PEAVEY ELECTRONICS INC.

IPR1600 Power Supply

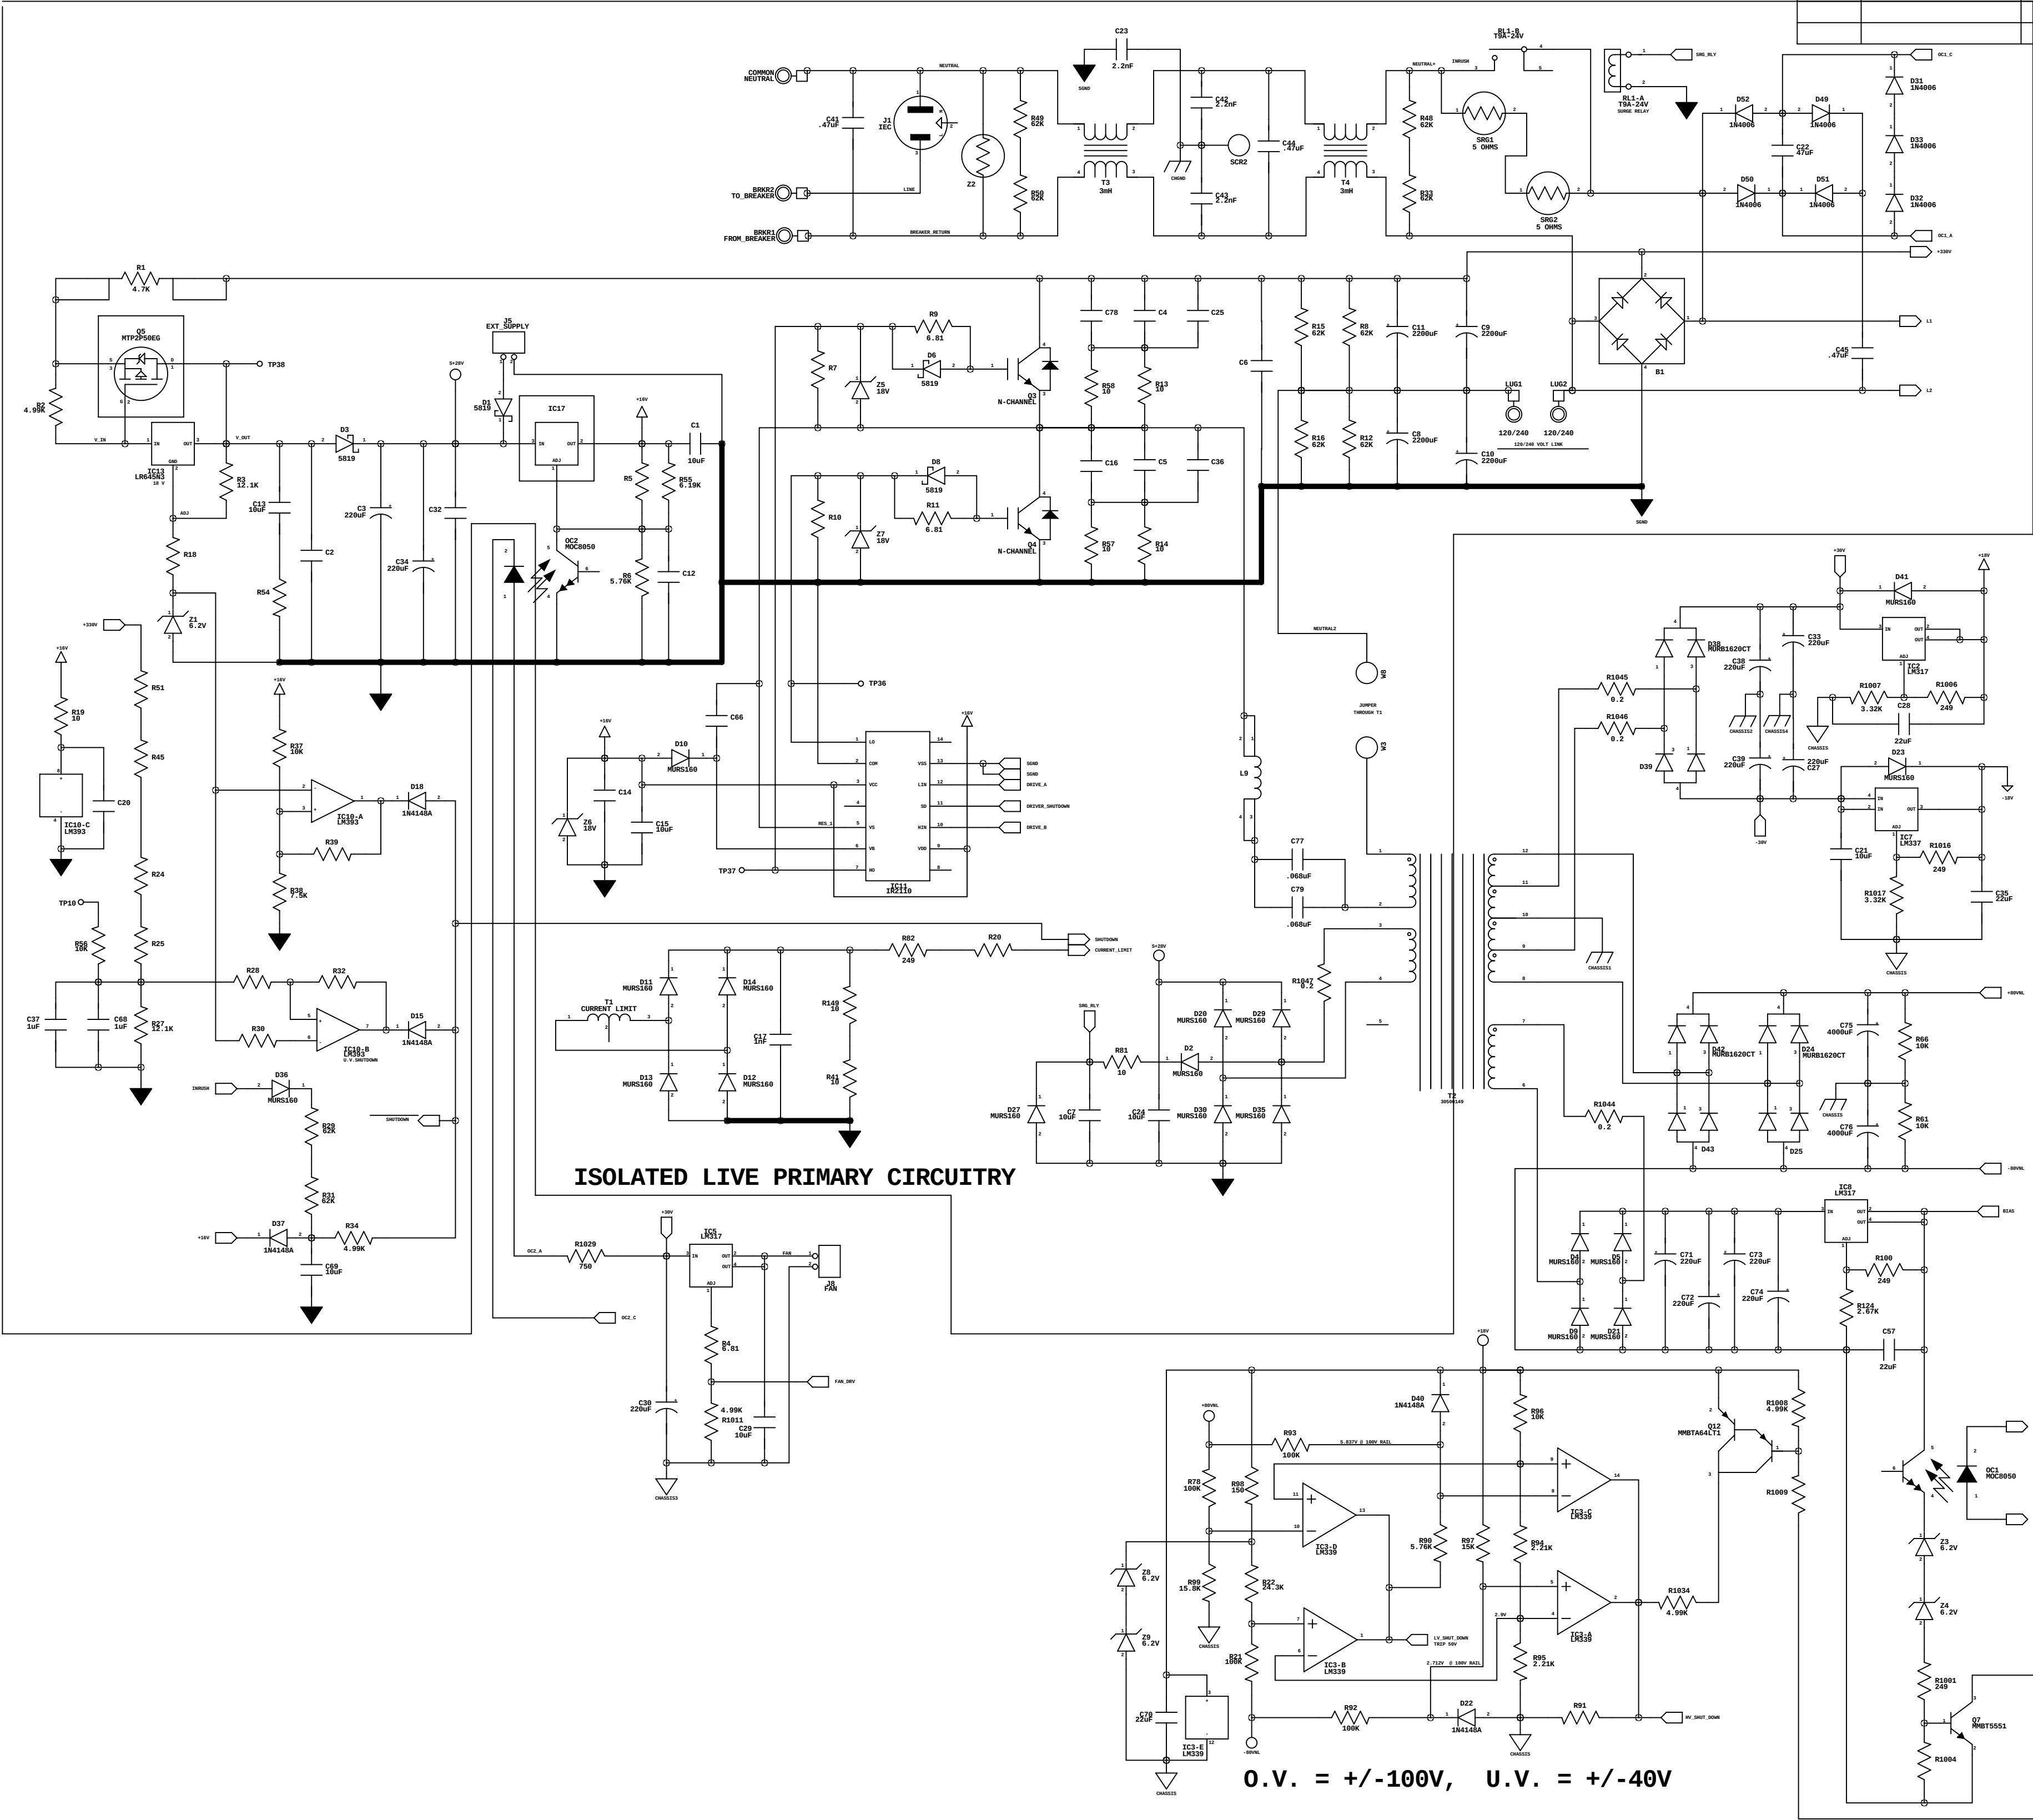
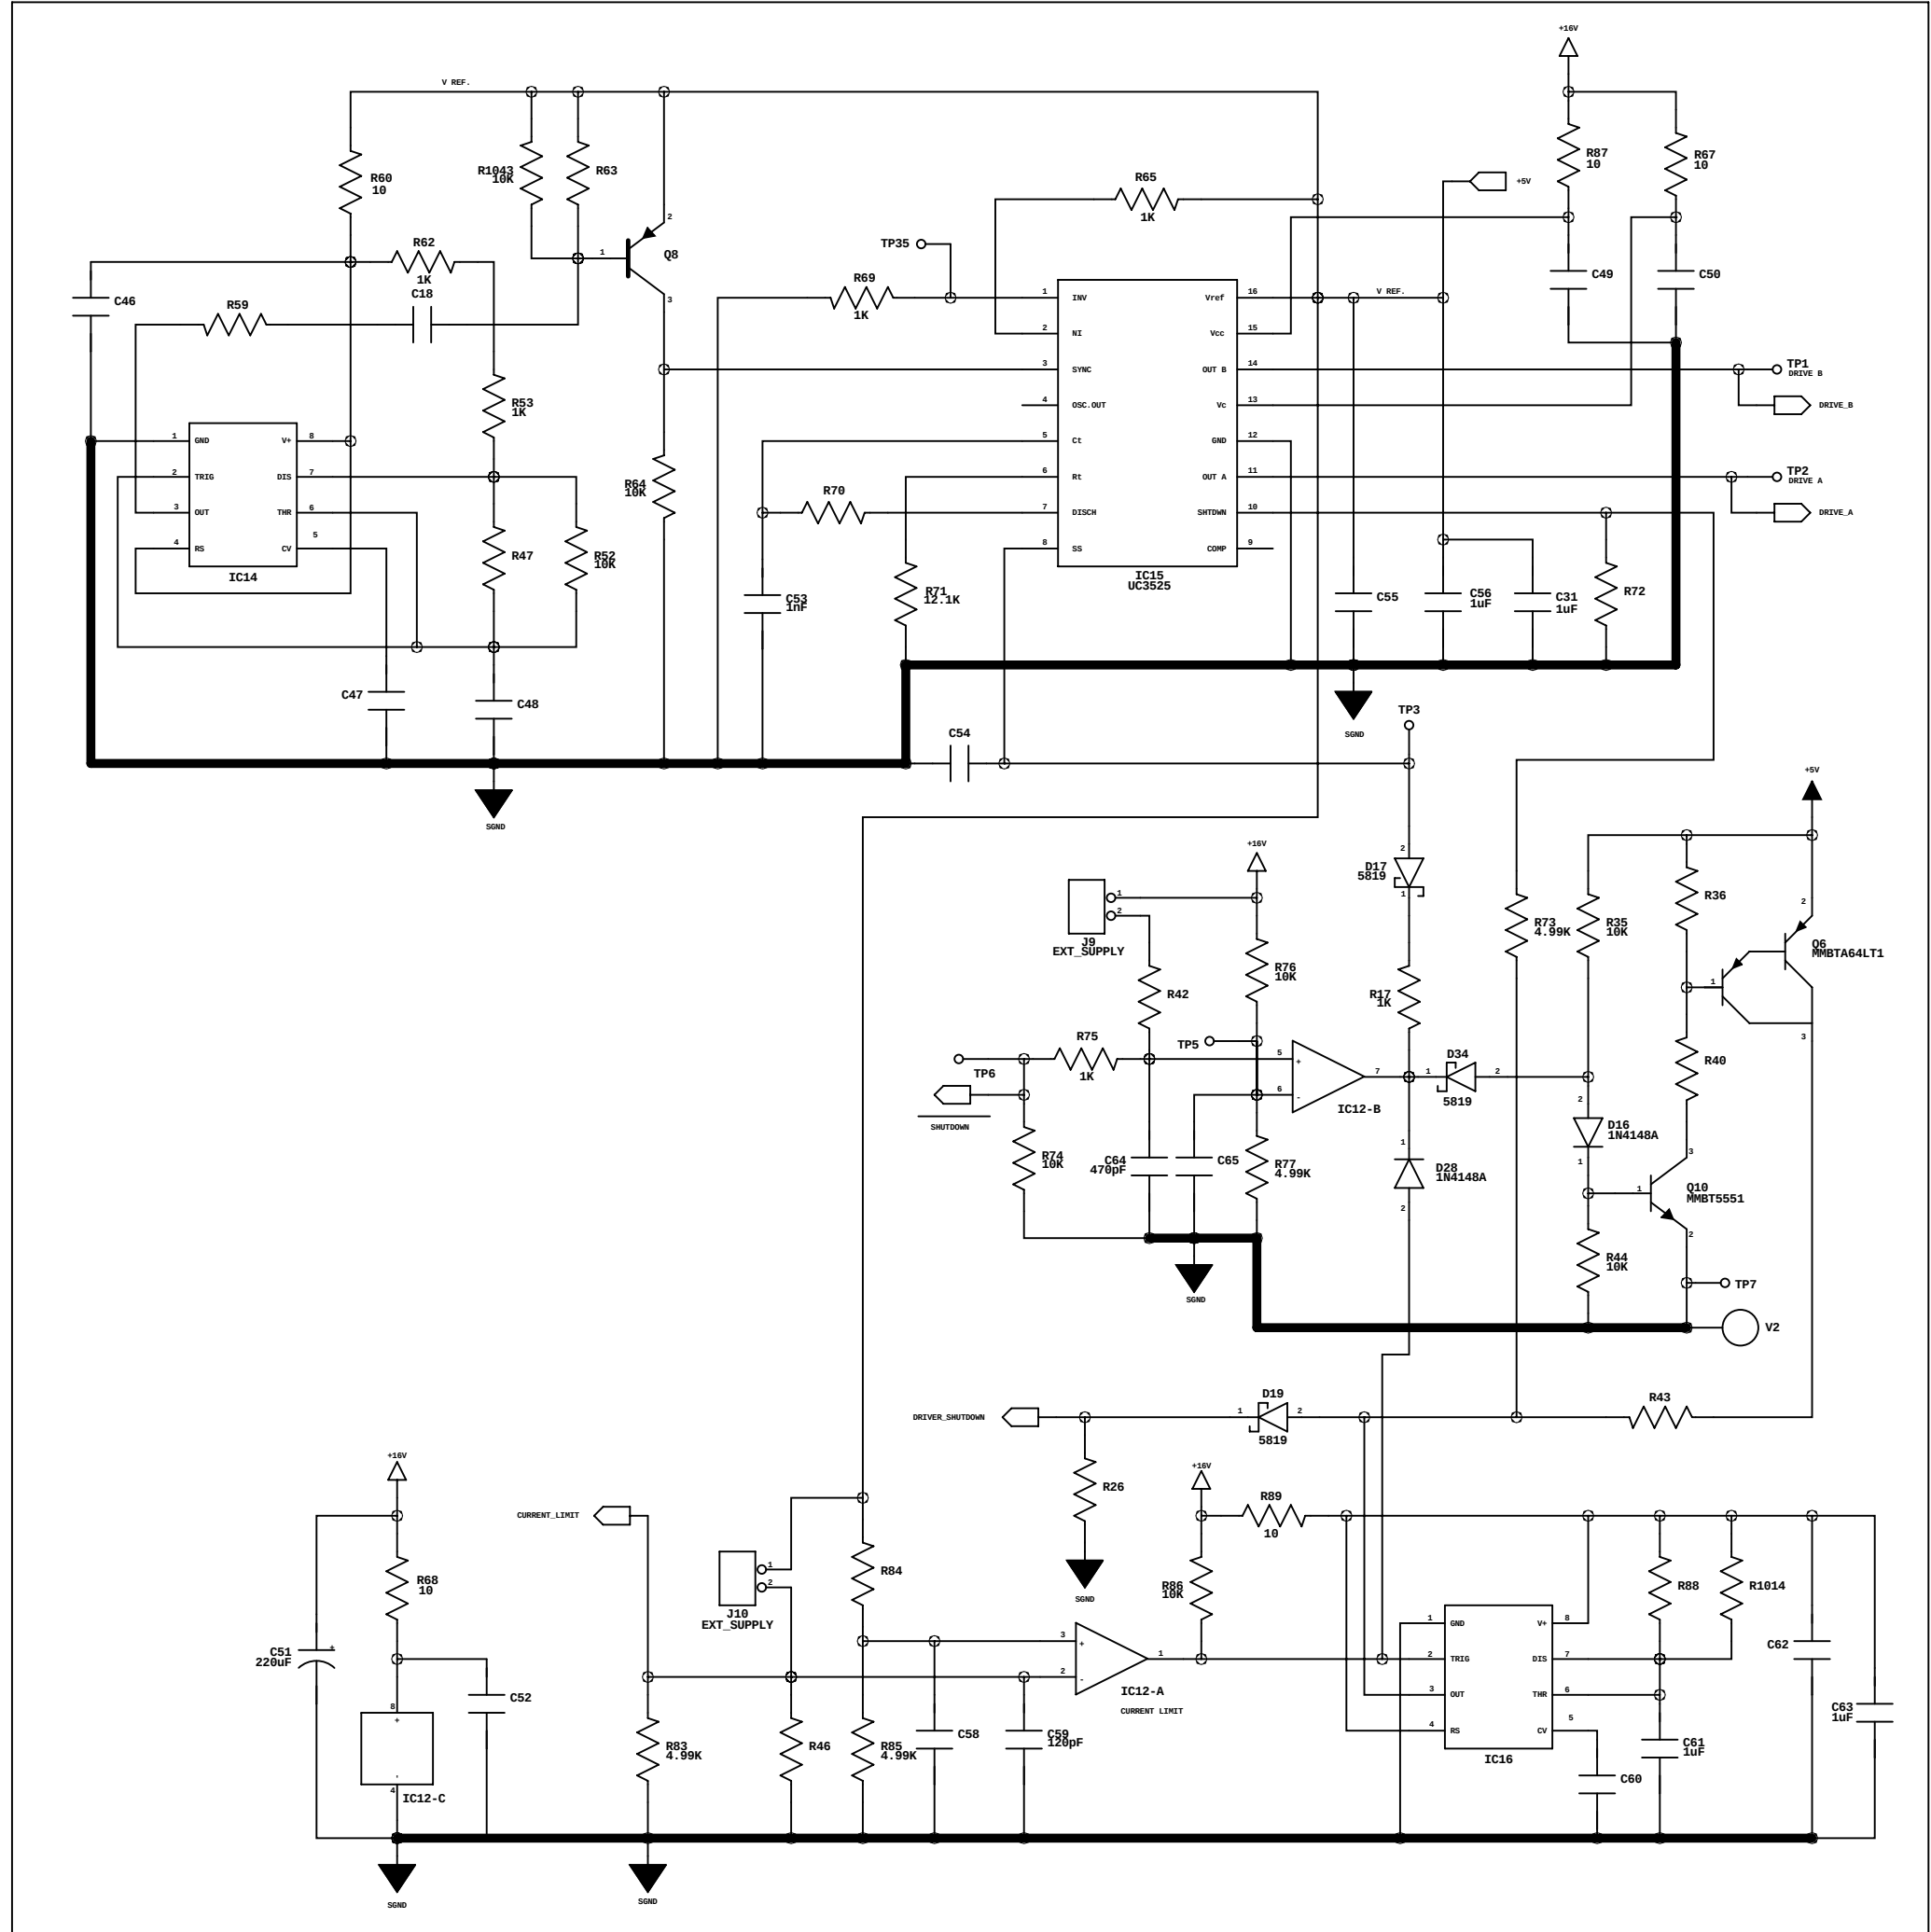
ECN22087:
11/16/09 Changed R90 to 5.23K
11/16/09 Changed R97 to 13.7K
01/06/09 Changed Q3, Q4 from 30400260 to 30418876
1/04/10 Changed vendor P/N for 33717261
1/04/10 Changed vendor P/N for 30450878
Changed 8 amp breaker to 9 amp

ECN22104:
02/05/10 Changed Rx15 & Rx16 from 511 (30200161) to 10K (30200051)

ECN22299
06/22/10, Changed C111, C146, C147, C211, C246, C247, from 30300111 47pF to 30300185 150pF.
06/22/10, Changed C22 from 30300108 10uF to 30300317 47uF.
06/22/10, Changed R90 from 30200252 5.23K to 30200564 5.76K.
06/22/10, Changed R97 from 30200535 13.7K to 30200334 15K

03/28/11, Changed MOSFETs to display 64-0078PBF

ECN22777
Changed D108, D109, D208, D209 from 30418272, ON Semi MURS160T3 to 30419246 RS3GB-13-F
